**LATROBE
AREA
HOSPITAL**

RE: Mail Control 136397
Latrobe Area Hospital
License No:37-09463-01

Please note the responses to your e-mail of 5/27/05 regarding the license renewal for Latrobe Area Hospital.

ATT(9.1
LATROBE AREA HOSPITAL
DEPARTMENT OF NUCLEAR MEDICINE

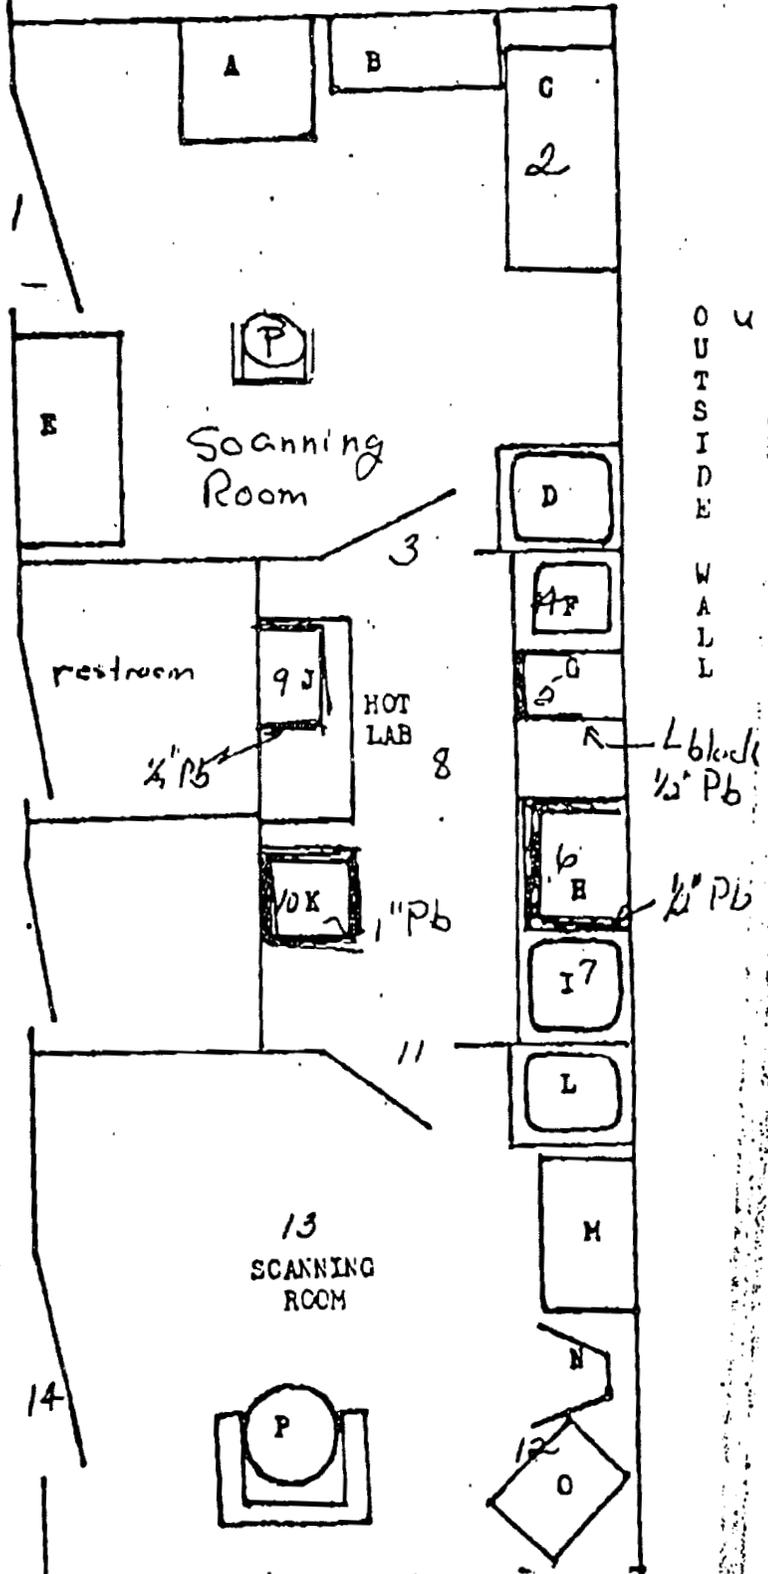
1. The only dedicated waste storage area is located in the Nuclear Medicine Hot Lab. This is a lead lined box for used kit vials and syringes. The box has 1/4" on all sides and on the top and bottom. The diagram of the Hot Lab was enclosed with the renewal application and is also attached to this letter.
